STRUCTURAL BLUEPRINT

G+1 Farm Storage + Residence

Mithanpur Urf Naimtulla Nagar, Moradabad, Uttar Pradesh

SHEET 10: INDEPENDENT STRUCTURAL REVIEW & RECOMMENDATIONS

SHEET 3: BEAM LAYOUT PLAN

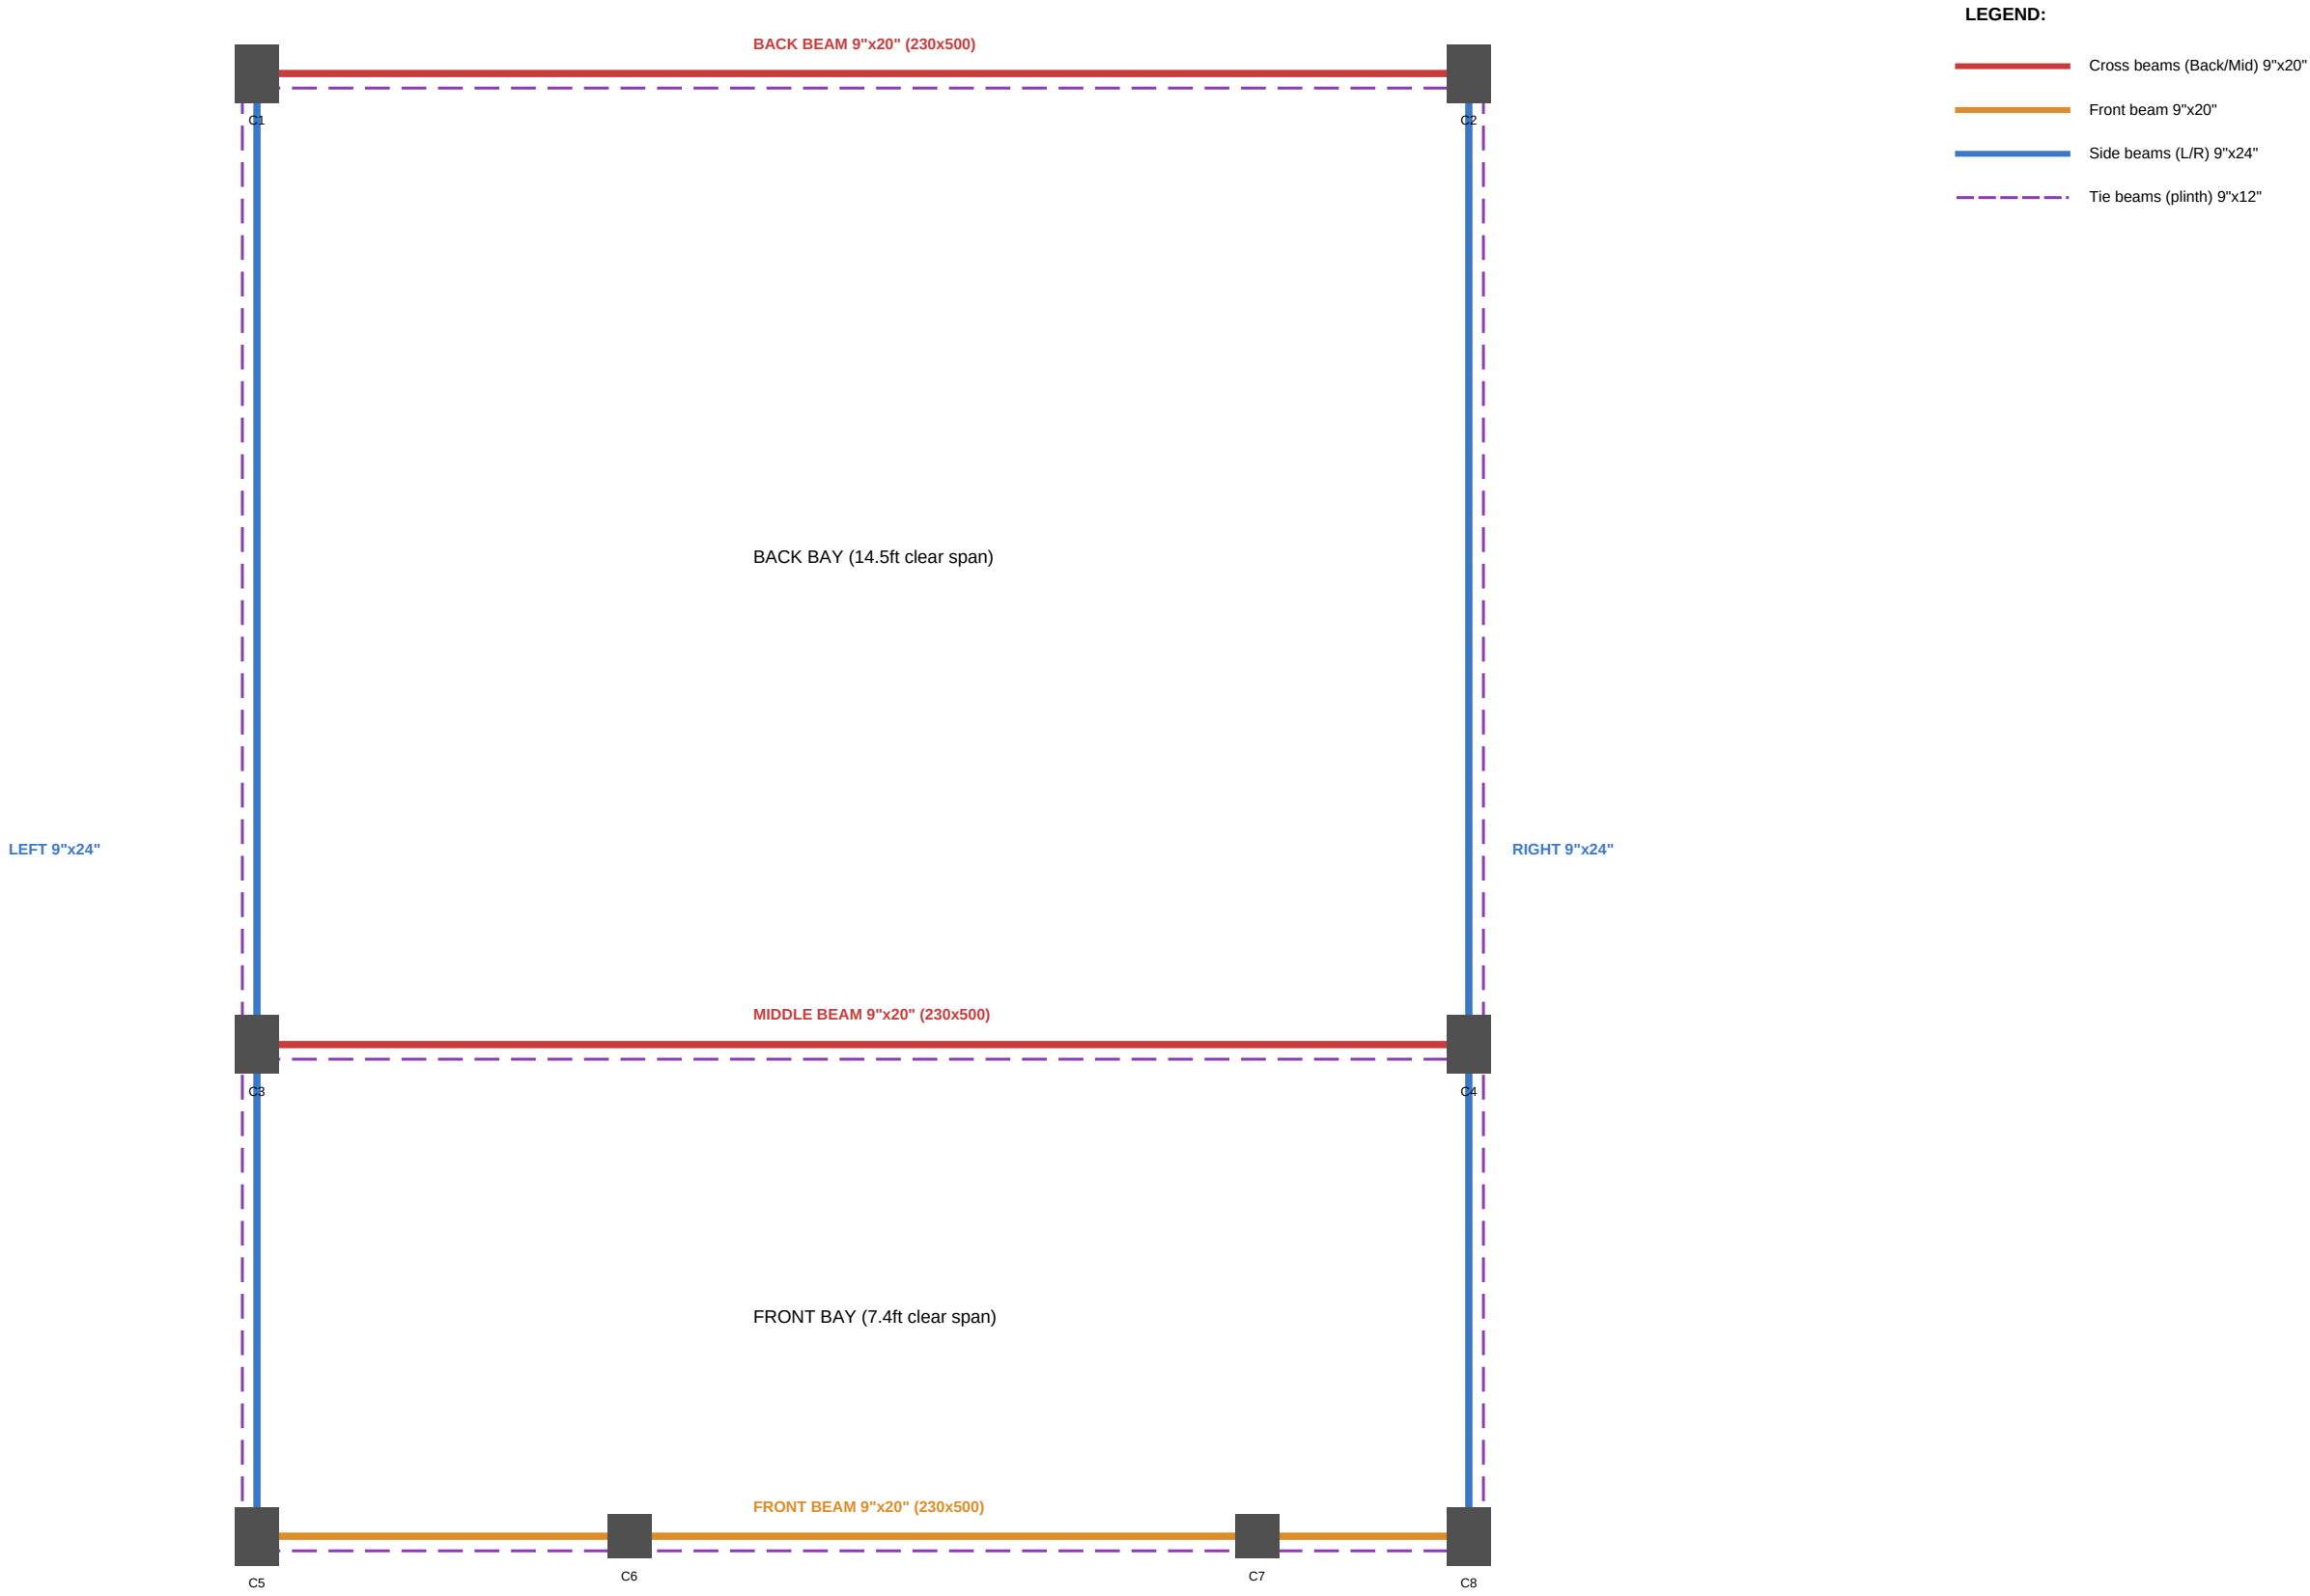
1. OPTIONAL PILLAR at x=7'1.5", y=8'5" (near middle beam, left of C6): Provides direct load path for staircase reactions into the middle beam. Reduces beam bending at that point.
Size: 9"x9" (230x230mm), 4-12mm steel, same height as GF columns. Low cost, high benefit.

5. SIDE BEAM MID-SPAN: If any deflection visible during construction, add MS angle bracket (100x100x10mm) as a knee brace from C3/C4 column face to beam soffit at mid-span.

SECTION A-A (Front to Back)

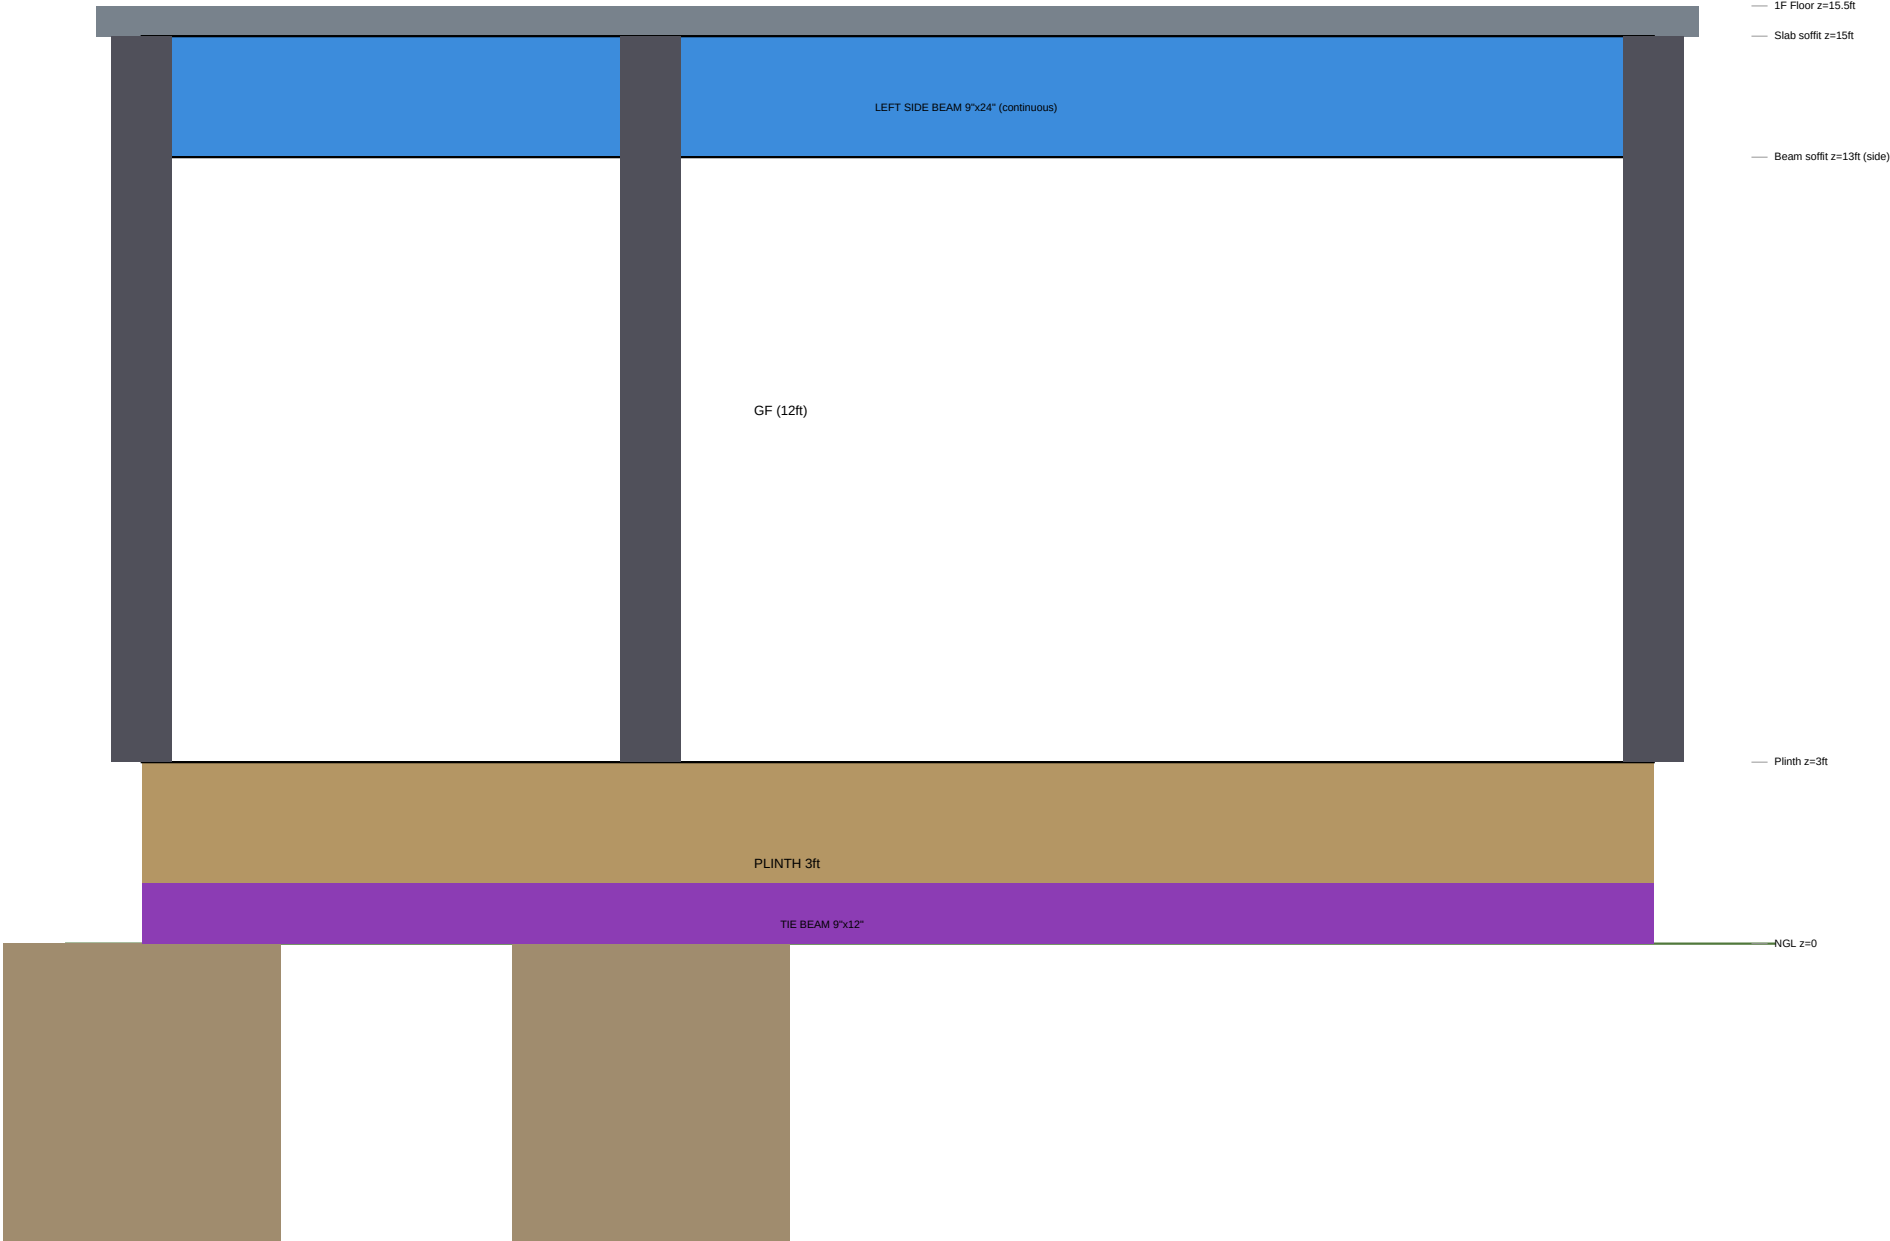
2. CANTILEVER EDGE BEAM: Add a 150x230mm upstand beam at the 6ft cantilever tip.
Reduces deflection by ~40%. Alternatively, increase cantilever slab to 175mm.
Cost: ~Rs 3,000 additional. Recommended for long-term crack prevention.

3. BACK BAY SLAB: Increase from 150mm to 175mm (7") for the back bay panel only (between middle beam and back beam). Resolves deflection concern (L/d improves to 28).
Cost: ~Rs 12,000 additional concrete + steel. Strongly recommended.
